Re: Downstream Facilities Capacity for Crossings at Mill Creek Apartments

## DOWNSTREAM FACILITIES CAPACITY REQUEST

## MEMORANDUM

**Date:** December 30, 2020  
**From:** Tyler Pelton, E.I.T. (Heritage), Logan Dixon, P.E. (Heritage)  
**To:** Joey Ashby (MSD)  
**CC:** Casey DeYoung, P.E. (Heritage)  
**Subject:** Crossings at Mill Creek Apartments Capacity Analysis

# Figure 1: Crossings at Mill Creek Apartments Capacity Request

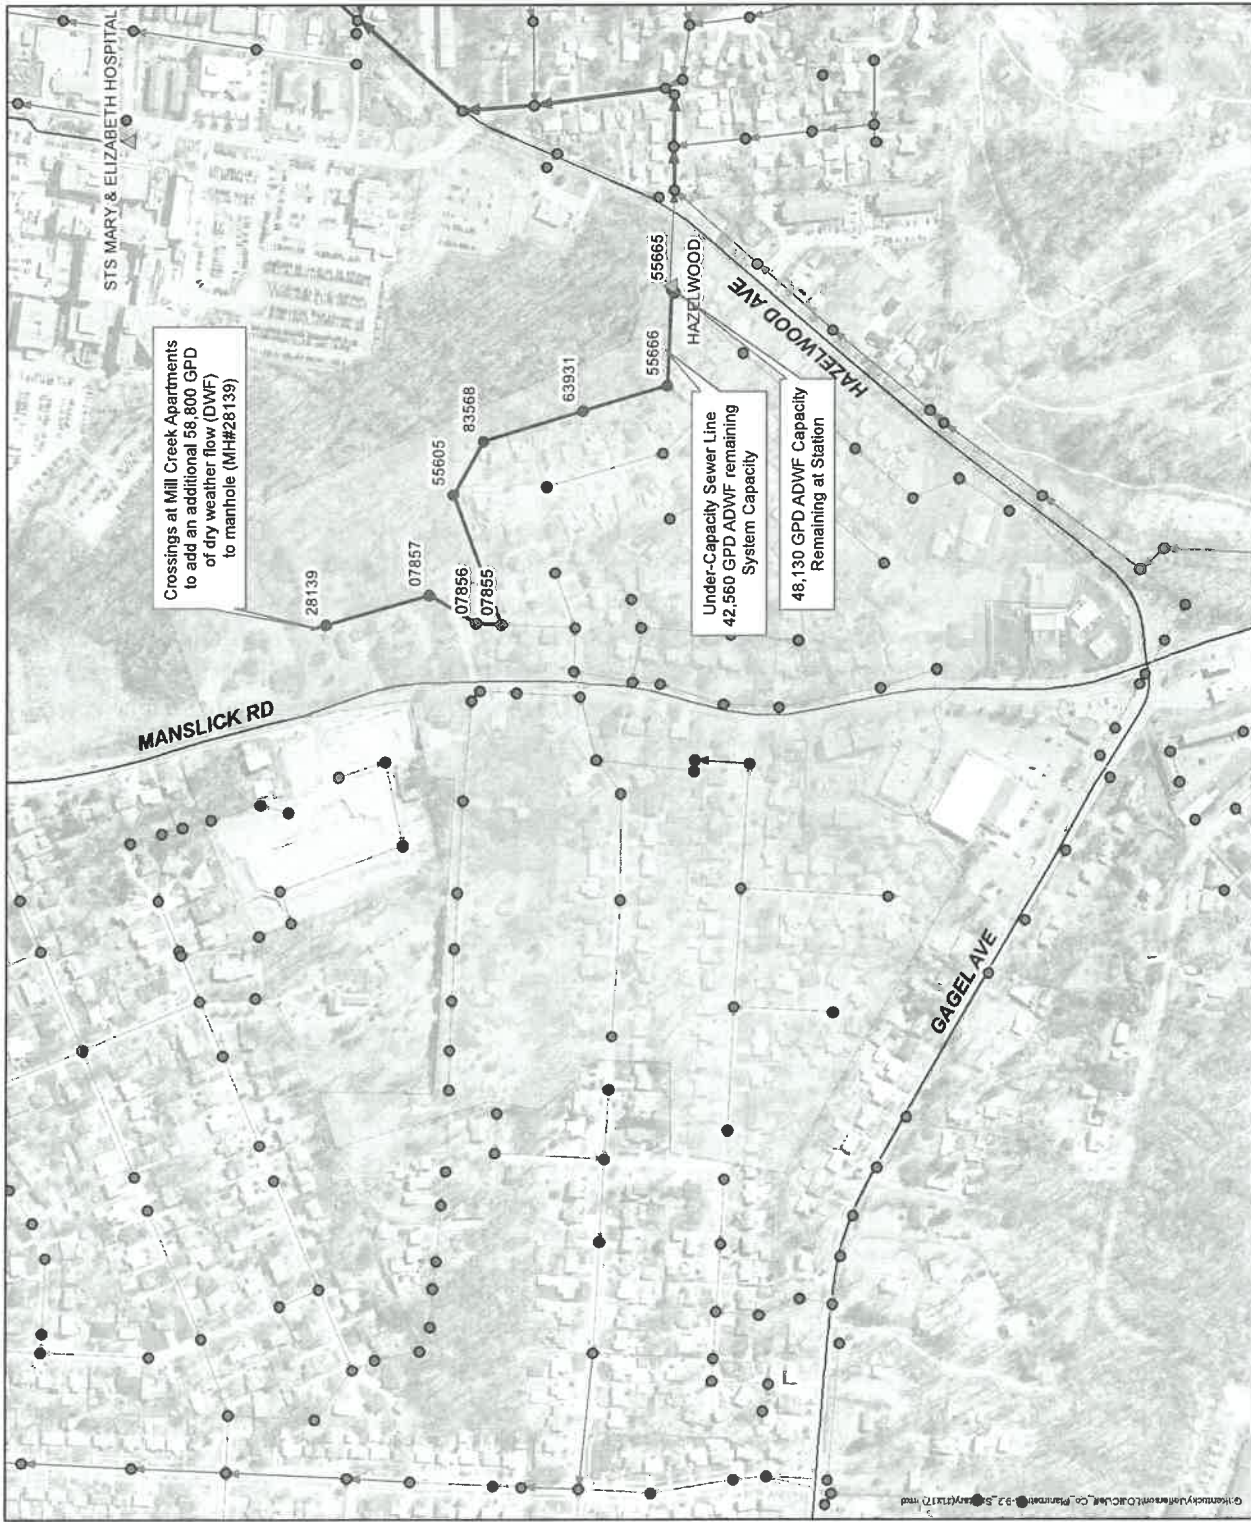
This memorandum has been prepared to assist MSD in processing a capacity request for the Crossings at Mill Creek Apartments to add an additional 58,800 GPD of dry weather flow (DWF) to manhole (MH#28139). The dry weather flow (DWF) capacity of the Hazelwood Pump Station (HPS) and the sewer lines between the pump station and MH#28139 were examined. No DWF modelling data is available for this area since it is located in the combined sewer catchment. In September of 2017, drawdown tests completed for HPS determined the firm capacity to be 198 GPM (285,120 GPD). Using pump runtime data collected from the MSD PI server, along with the available drawdown data, the HPS was determined to have an average daily DWF of 25,308 GPD. This observed average DWF is less than the calculated average DWF capacity of the pump station (73,438 GPD), indicating that the current pump station has adequate capacity for existing DWF and an additional 48,130 GPD of average DWF capacity. The analysis area can be seen in Figure 1.

Figure 2 - Existing Flow

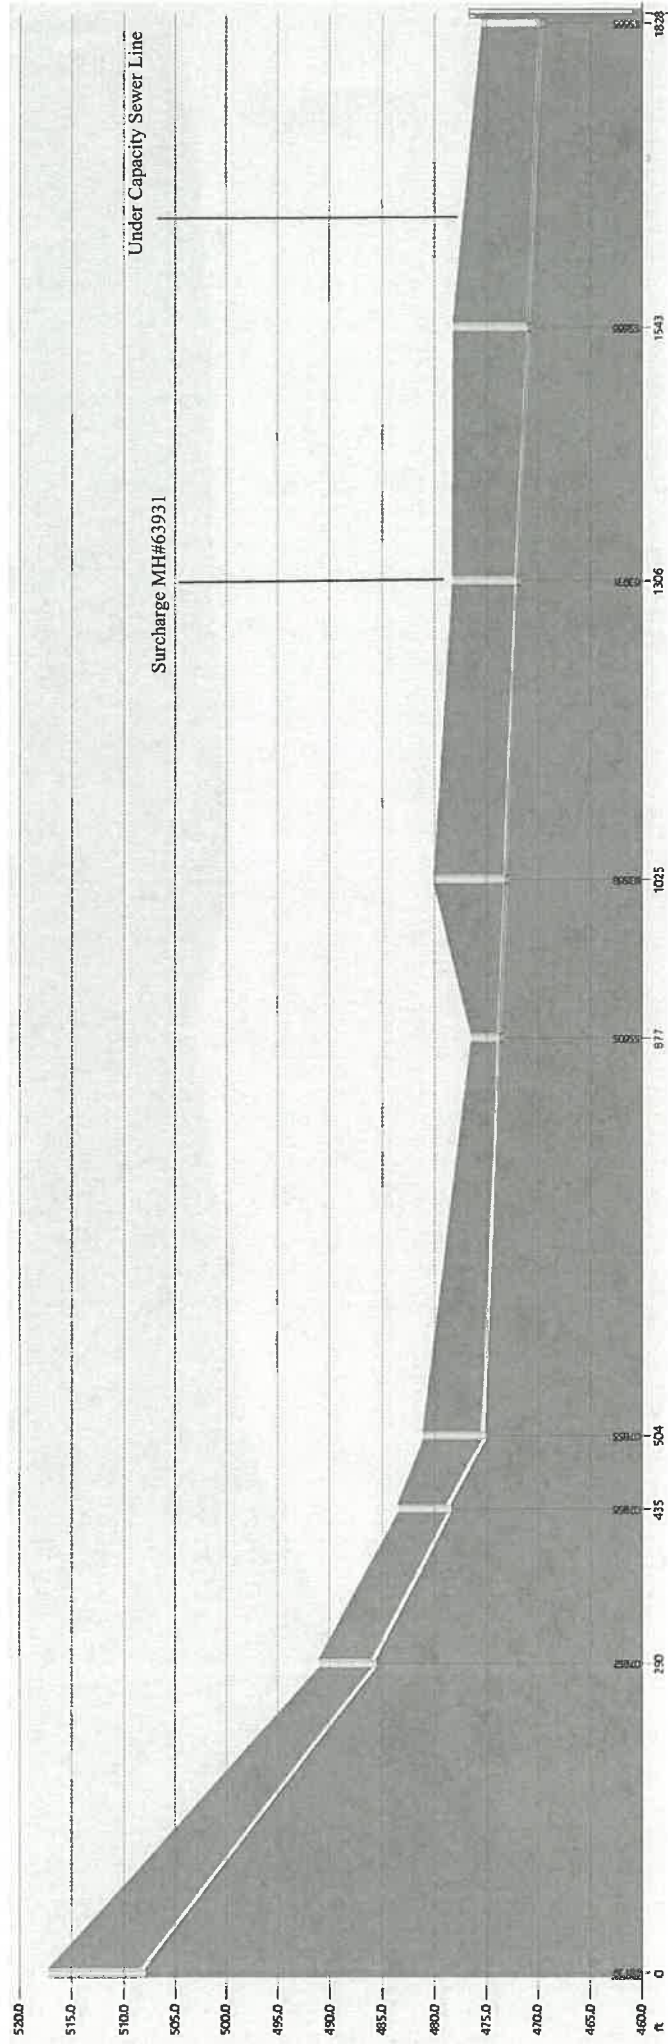
An analysis of the sewer system upstream of the pump station shows that 40,980 GPD of additional average DWF flow can be added to the system before surcharging from the under-capacity pipe downstream of MH#55666 exceed the crown of the pipe of the upstream MH#63931. Some surcharging exists at MH#55666 but is not within 6' of the ground elevation. The pipe at MH#63931 is less than 6' deep. Figures 2 – 4 shows the sewer pipes with existing flow, the maximum allowed flow, and the requested flow.

As can be seen from the summarized results, the pump station nor the sanitary sewers have capacity for the requested flow. Up to 40,980 GPD can be approved based on the existing system capacity. Pump upgrades and 1,324 ft of pipe upgrades (8-inch upsized to 10-inch) would be required to approve the full amount of requested flow. Alternatively, a flow monitor can be installed to verify the existing flow in the system. If the actual flows are less than the flows calculated in this analysis, the development could potentially be approved without requiring additional improvements to the existing system.
